APPLICATIONS NOTICE

ISSUE NO. : 01/15
DATE : 6 March 2015
FROM : T King

SUBJECT: CONNECTING ALTERNATIVE THERMOSTATS
(NON-COMMUNICATING CONTACT SWITCHING TYPE)

UNITS: OPA 116–201 c/w UC7 and 24V relays removed, and
ISD/OSA 116–224 with IUC/UC8

Connecting a thermostat or other controller to the UC7 using 12V DC control signals.

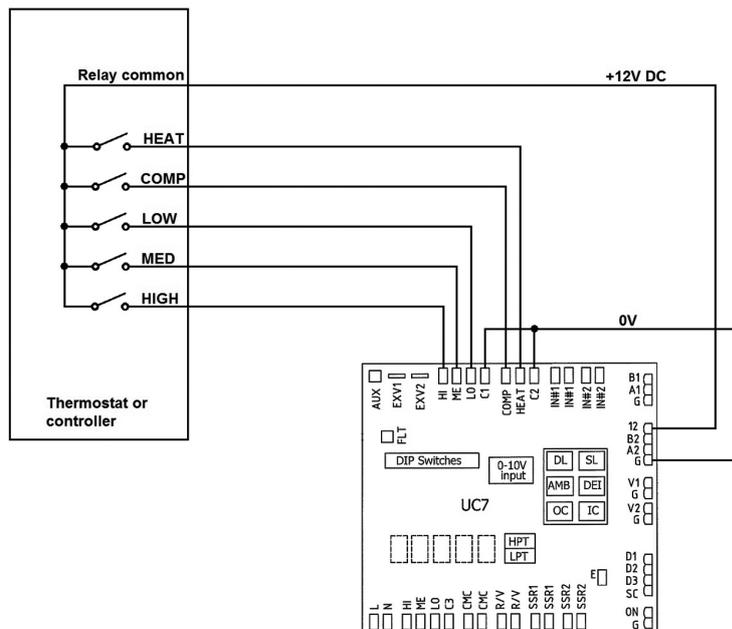
Recently it was decided to remove the 24 volt control relays from the small over/under OPA range of units containing UC7 unit controllers as they were seemingly superfluous to requirements.

As a result it may have become a little confusing when making the electrical connections and using a conventional thermostat.

The connections that were previously made to a terminal block labeled HOT 24V, COM 24V, COMP 24V, HEAT 24V, LOW IN 24V, MED IN 24V and HIGH IN 24V will now be made directly to the UC7 unit controller PC board.

Connecting a thermostat or other controller to the UC8 using 12V DC control signals.

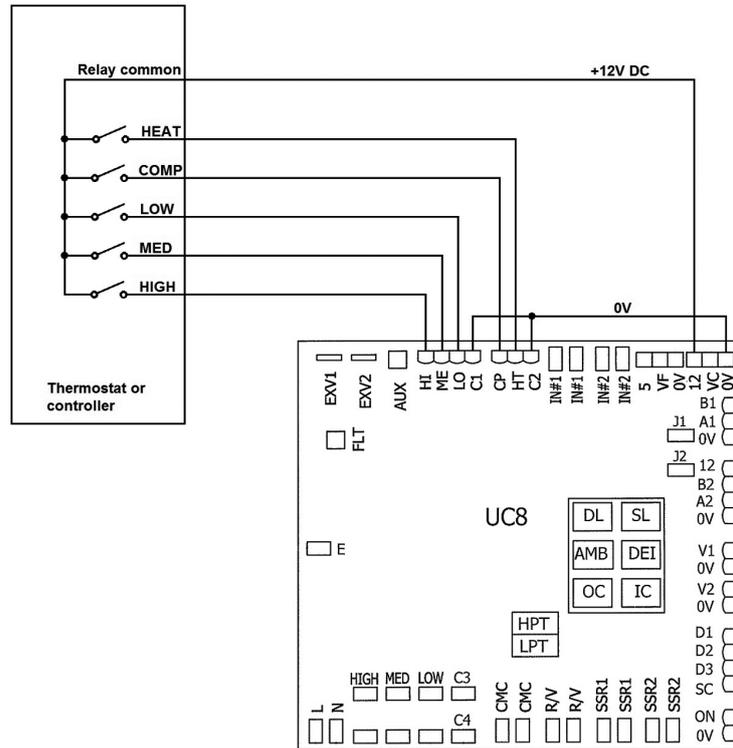
The same wiring detail will also apply to the new 2015 range of OSA split system units utilizing the UC8 Unit Controller, however, the terminal shown above labeled as 'G' is labeled '0V' on the UC8 (refer diagram overleaf).

Connecting a thermostat or other controller to the IUC.

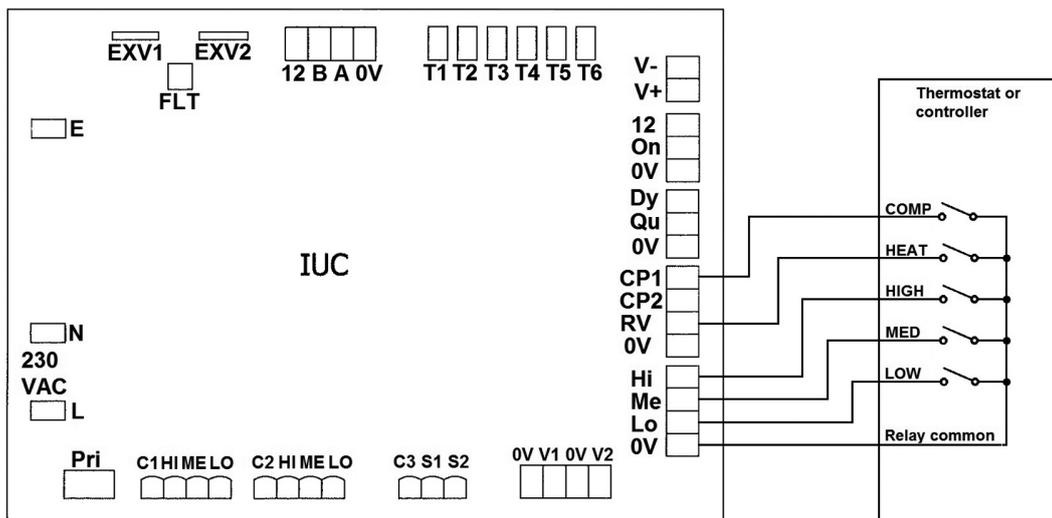
The new range of ISD/OSA units will also have the option of an alternative thermostat being connected to the IUC (Indoor Unit Controller) on the indoor unit instead of the outdoor unit. The wiring is similar but the layout is somewhat different and is shown below:

Connection to 0V on this diagram is not an error.

NOTE: DO NOT try to connect an alternative thermostat to both the IUC on the indoor unit and the UC8 on the outdoor unit. It is one or the other not both.
